#### INLAND WETLANDS AGENCY REGULAR MEETING AGENDA MONDAY, MARCH 8, 2021, 7:00 P.M. TOWN HALL ANNEX MEETING ROOM, 57 MAIN ST, ELLINGTON, CT

1. IW202102 – Andrian & Cheryl Kebalo owner/applicant, request for a permit to conduct regulated activity to construct an addition with a one car garage to an existing home and associated site improvements at 1 Crystal Street, APN 149-069-0000.

Re: Response to Staff Comments Application # 1W202101 261 Windsorville Road, APN 014-006-0015.

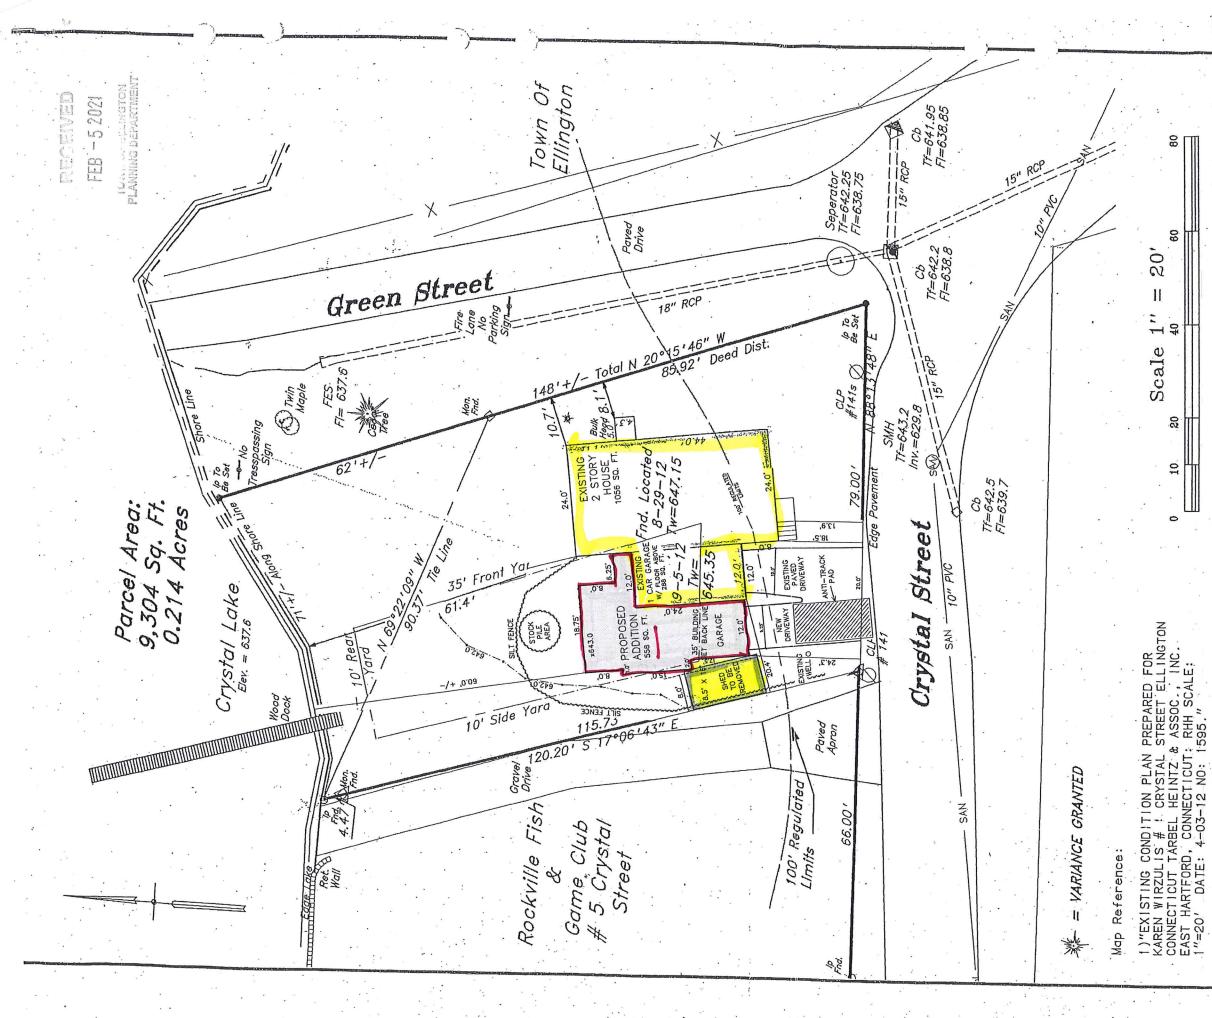
DEPARTMENT	COMMENTS AND/OR REQUIREMENTS
Town Engineer	-If Porous pavement or permeable pavers are used no drains or drainage pipes are allowed within 25' of the water supply well.
	-The plan does not specify how the well will be protected; Surface water must be directed away from
	the well.
Building Official	- If recent water quality testing has not been conducted it is recommended to test the water before construction and after completion of all site construction activities.
North Central District Health Dept	
Fire Marshal	
Public Works Director/WPCA	
Assessor	
Traffic Authority

Appears as Driveway permit will be required along with plans for the second story of the garage. Bedroom, bathroom?

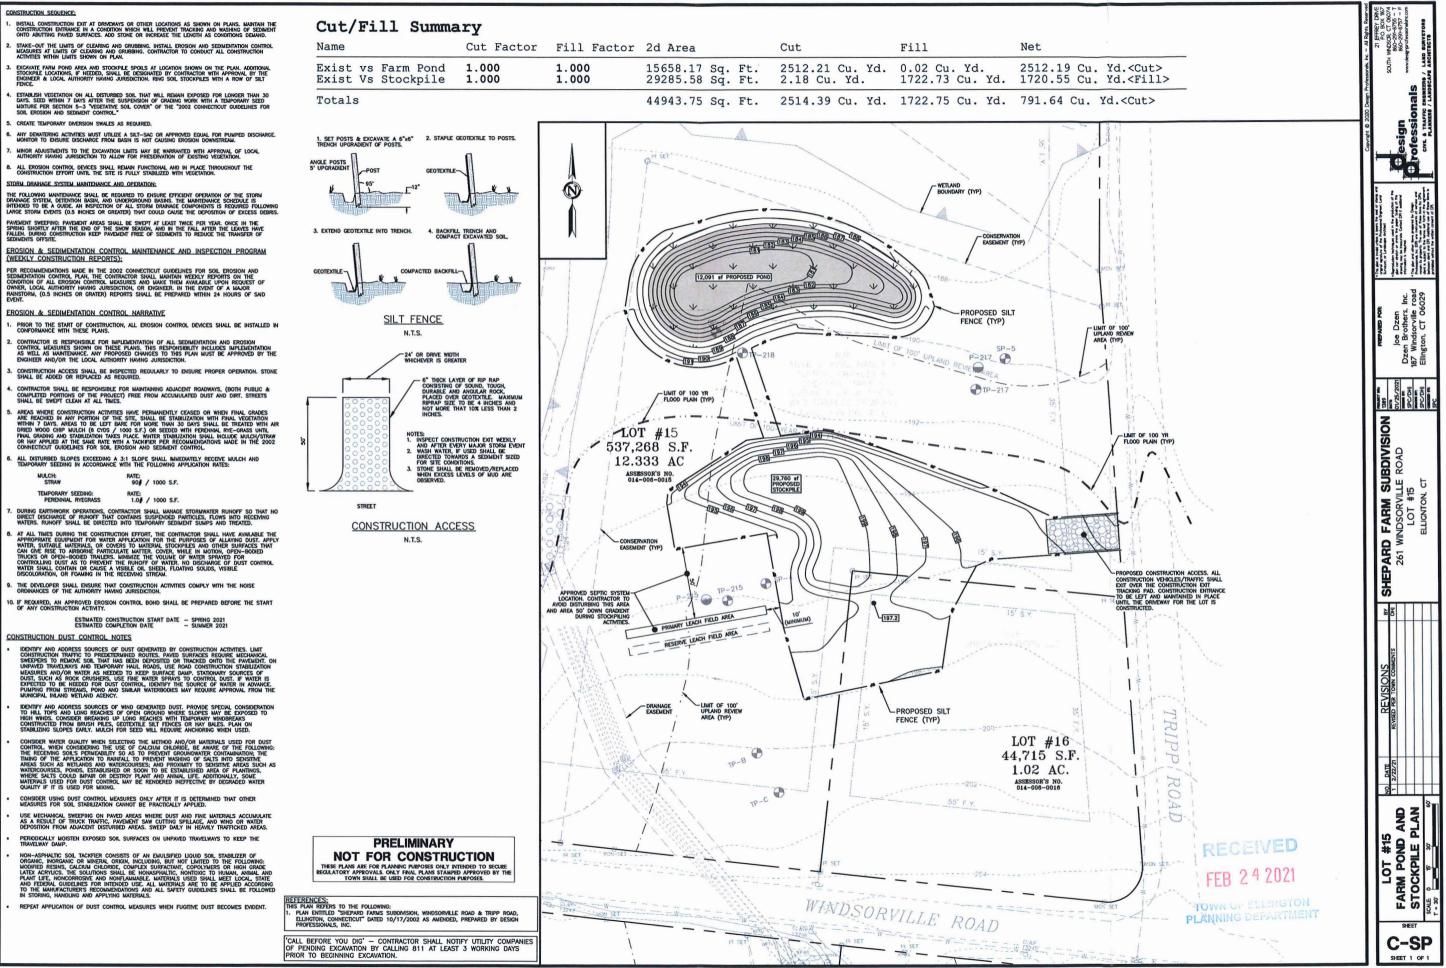
1. Comment from Director of Public Works, Tim Webb received (01/29/2021): "Driveway permit will be required and should be paved to accommodate /support a vehicle."

2. Comment from North Central Health District Received (02/19/2021): 261 Windsorville Rd. Lot 15 and 16 located on the corner of Tripp Rd. Ellington updated site plans have been reviewed by NCDHD as recently as 2018 with approved septic system areas. The septic system area, hydraulic window and reserve areas are not shown or addressed on this plan. No mention of how those areas will be protected from site disturbance is shown, where there might be site disturbances that would affect nearby Approved Septic areas the Plans must be amended now – to show that those areas will not be disturbed – Or the applicant is taking the risk that the pond may possibly render Lots 15 & 16 unbuildable – depending on the extent of the soil disturbance. The proposal for the Pond should show the proposed septic areas including the hydraulic window, reserve areas within this area, adjoining lots and all around. The Plan should outline Areas to be avoided during the Pond's Construction and specify the areas that must be left undisturbed for protection of the native soils within the future septic system areas whereas site soil disturbance of the natural soils within the septic system areas could render the lots unsuitable in the future.

3. Comment from Ellington Town Engineer, JR Russo Received (02/19/2021): I've reviewed the plan to construct a farm pond on Lot #15, 261 Windsorville Road. The plan calls for excavating 2,500 c.y. of native material from the pond area and stockpiling the material upgradient on Lot 15 & 16. Proper measures are proposed to control erosion and stabilize the site after construction. I take no exception to the plans as submitted. You may want to require an erosion bond to ensure final stabilization. Let me know if you have any questions.

The plan was revised to include additional measures on the call out for the construction access location, requiring it to be left and maintained in place until a driveway for the lot is constructed. We respectfully would like to hold off on installing a paved driveway until a final house plot plan for the lot is considered.

The plan was revised to show the approved septic system location and restrict disturbance 50' down gradient and 10' on the sides of this area.

Noted
